**PLANNING AND
DEVELOPMENT DEPARTMENT**

SR-2 – ADVISORY STAFF REPORT (08-07-2026)

ADDRESS: 14529 GLASTONBURY

SCOPE: REPLACE FOUR STEEL WINDOWS WITH ALUMINUM-CLAD WINDOWS

Interior photo of the north-side kitchen window. It is a centered casement window with fixed windows surrounding it and it appears to staff that a crank may be missing. An awning window is proposed to be installed. (Applicant photo)

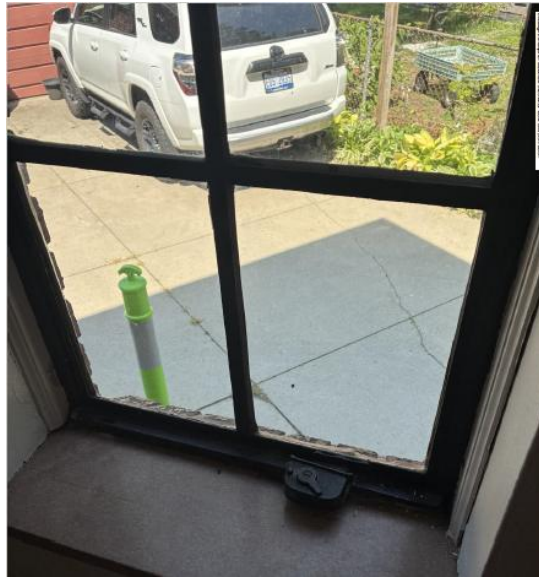
- Applicant proposes to replace existing windows with wood windows with reddish aluminum cladding (“Brick Red”) and they propose to use wood brick mold trim painted to match. The muntin pattern is proposed to stay the same with each window to be replaced. Staff notes, however, that the proportions would change with the replacement since the steel windows have operating sashes and fixed panes, and the widths of those components vary, whereas the replacement window muntins are all the same width. It is also possible that the replacement muntins do not have the same profile/dimension as the existing, so the result may also be a “flattening” of the windows with the replacements.

- Steel window operating sash width is 1 1/8” and steel muntins are 5/8”, whereas muntins in replacements are 7/8”.
 - Additionally, the steel windows have thinner frames as compared to the proposed replacements.

- The steel perimeter frame width is 1”, with 3/4 inch exposed when the inside window casing is in place, whereas the replacement window’s frame is 2 7/16” wide. The applicant describes the installation method and states that the “Interior plaster role back will be filled to the window’s interior and finished with wood trim.”

- Applicant describes that the windows are in poor condition, with some broken mechanisms and some missing screens. Staff did not receive repair estimates or information about potential replacement components.

1. The extant steel windows are distinctive and historic, character-defining features of the building. The submitted application materials do not substantiate that these windows are deteriorated beyond repair. Storm window installation, subject to staff review, should be considered as an option.
